NORTH SYDNEY COUNCIL REPORTS

NSLPP MEETING HELD ON 05/11/2025 SECTION 4.56 APPLICATION REPORT

ADDRESS: 1 Eden Street, North Sydney

APPLICATION No: D274/21/4

Figure 6: Proposed Ground Floor Plan

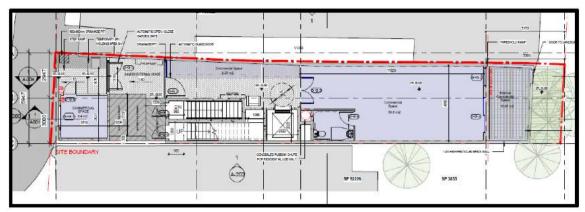
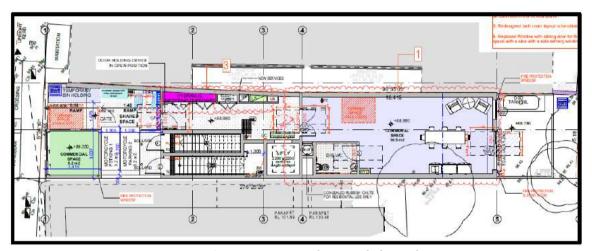
| Building elements | Differences | Quantitative and qualitative changes |
|-------------------|--|---|
| Ground Floor | Service and utility cupboards replace 9.25m² of commercial floor space in hallway. Commercial floor area replaced by common room for boarding house. On-site detention tank located in semi-enclosed commercial area at rear (eastern) end of the building side. Although not specified, the approved enclosed commercial space appears to be made accessible from the common room for the use of boarders. | See comments below table. |

Qualitatively, this change reduces the amount of available commercial floor space in a mixed-use area on the edge of the North Sydney CBD. Due to design and a relatively balanced mix of land uses, the Eden Street locality operates compatibly as a discreet urban village, yet integrated and accessible from surrounding areas.

Maintaining, not reducing, the quantum of commercial floor space is of considerable significance, so the development contributes to a balanced mix of uses in the Eden Street locality. This aspect of the proposal supports a conclusion that the modified development substantially differs from the approved development.

Figure 10: Proposed East/West Elevations

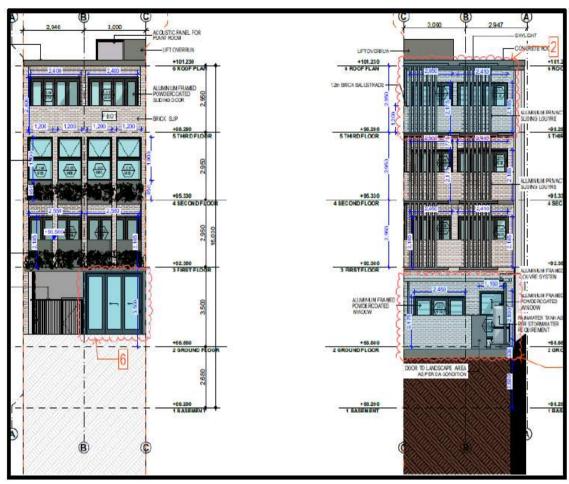
| Building elements | Differences | Quantitative and qualitative changes |
|--------------------|---|--|
| Northern Elevation | Although the plans are not clear, they appear to indicate a glass or solid screen about 1.8m high is to be built on the northern side of the balcony, abutting a solid wall of the building next door (probably BCA non-compliant). | This modification does not substantively impact the substantially the same test, being quantitatively and qualitatively insignificant. |
| Southern Elevation | At the eastern end of the building vertical floor to roof Louvres extend about 1.5m westwards from the eastern edge wall of the balcony, with the remaining part of the space being enclosed by what appears to be a glass panel, or window. This has the effect of increasing the bulk and scale of the eastern end of the building. | The submitted plans indicate the rear setback/building envelope control has been measured from the ground floor level instead of the existing ground level at the boundary. This has the effect of reducing the apparent degree of non-compliance with the DCP's rear setback control. |
| Eastern Elevation | To divide the approved common balcony into two private balconies on level 3, the elevation shows that sliding louvres are proposed outside the balcony edgewalls, and the obscured glass screen has been removed from the top of the balustrade wall. | The design amendments on level 3 as indicated in the plans and elevations increase the bulk and scale of the building, as detailed above in relation to the level 3 plans. |
| Western Elevation | A servery window to the retail area on the ground floor facing onto Eden Street is proposed to be replaced by sliding aluminium framed glazed doors. | This modification is not germane to this comparative analysis. |

5. Extending the units and eastern balconies to the eastern building edge on level 3

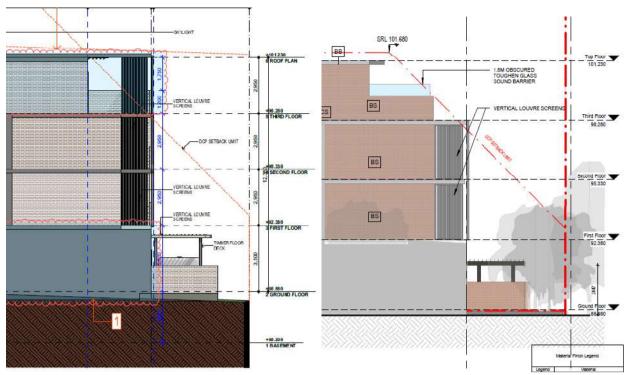
This change directly conflicts with amendments made during the conciliation process of the appeal, enabling the level 4 (roof top) common room (effectively the fifth level) and balcony on the western end of the building to be relocated to the eastern end of the building on level 3.

It was agreed to as a means of reducing the adverse impacts of the proposed height and rear setback breaches, and consequent reduction of amenity (privacy and to a lesser degree, solar access) and overbearing presence when considered from the perspective of the adjacent heritage item and its use as a guesthouse or hotel and adjacent residential properties.

Further, maintaining privacy to the south and east is proposed to rely on physical screening, which is less effective that than the approved setbacks (especially to the east) and as previously stated, adds bulk where there is none in the approved plans.

In this context, these modifications are significant in causing the development to differ substantially from the Court-approved development.
